Our ref: EJM/CE/17016-03

28th April 2016

RE: THE FUTURIST, LIME STREET, LIVERPOOL

Basement Plan (front only)

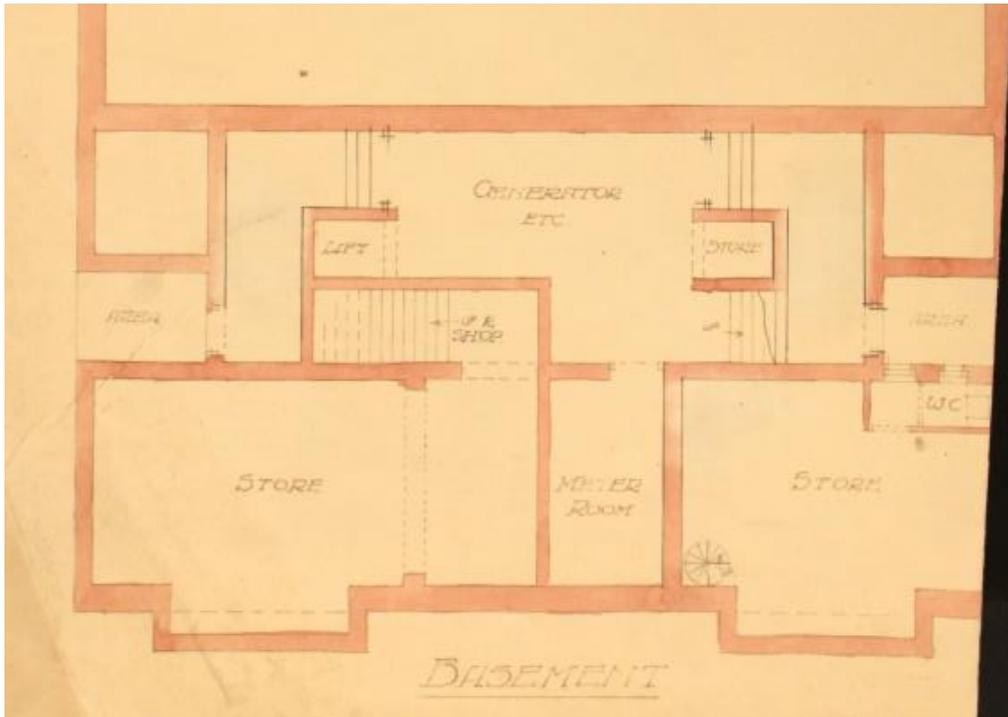
Firstly in the basement there are two cross walls, one positioned where I expected (13 ½" thick I suspect) and one additional one, albeit appearing slightly narrower (9" thick I suspect). There appears to be a steel beam under the second position I was anticipating seeing a wall.

This is positive as it shows that there are some walls which have a buttressing effect on the front wall, and thus will assist with any temporary works scheme externally, by helping resist any surcharge developed. Of course this depends on them being in reasonable condition.

I was then also considering why there does not seem to have been any attempt to access the basement. It may be that the floors to the two rooms, or shops, either side of the foyer have collapsed (I was not shown into these during my visit). But with a careful sequenced methodology I would imagine that access ought to be possible. If that was the case then providing a small raking shore, or similar, to the front wall in the position of the assumed beam would further assist with potential surcharge, and could of course be replicated elsewhere in its length. It would be good to establish the principal of access to the basement with the City Council.

Secondly the basement plan shows the brickwork steps out towards Lime Street, to each shop unit (see attached part basement plan). Again subject to inspection of condition this may mean that any temporary steel frame structure may be able to reside over this and thus the walls would be in compression rather than surcharging the basement wall with lateral pressure. It also means that services in the pavement should run outside this line. This would be subject to checking the alignment of the walls carefully, their condition and also thickness and thus their ability to take load without buckling. Of course the plan of the front wall at basement level, with the steps in its length will also provide some stiffening to resist this action, as opposed to a continuous wall along the length of the building.

Second Floor (front only)

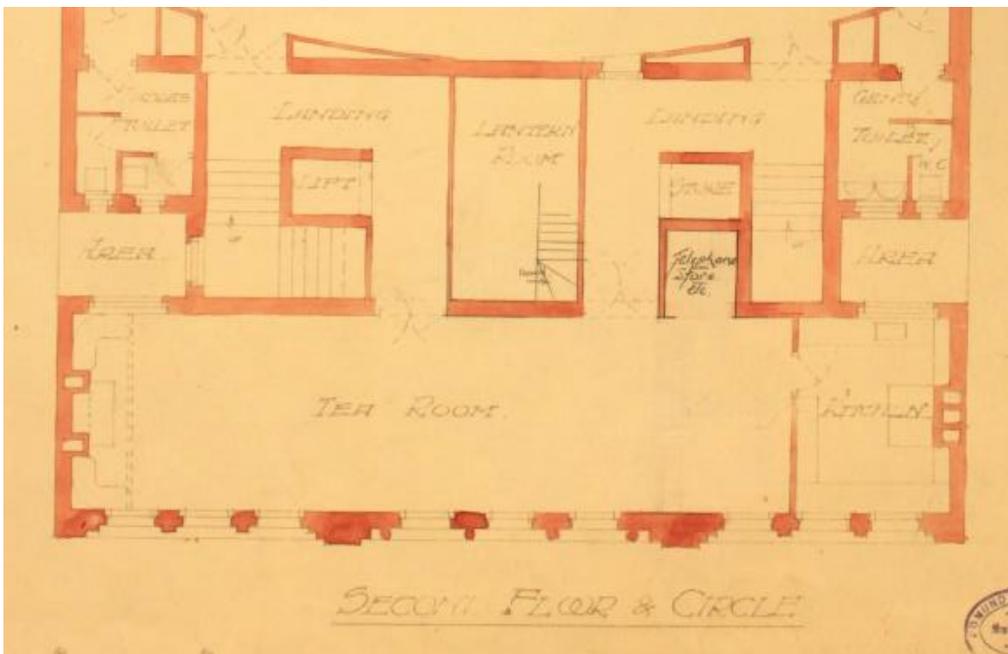
The second item which comes out of the plans is that the second floor plan shows that, in fact, this was largely an open space (a tea room) then with a kitchen at one end. However now there are more cross walls. This leads me to the conclusion that the out of plumb of the front elevation occurred prior to the insertion of these cross walls, as otherwise there would have been movement cracks, and thus I conclude that no movement has occurred since the walls were added. This is with the exception of the wall which is strapped.
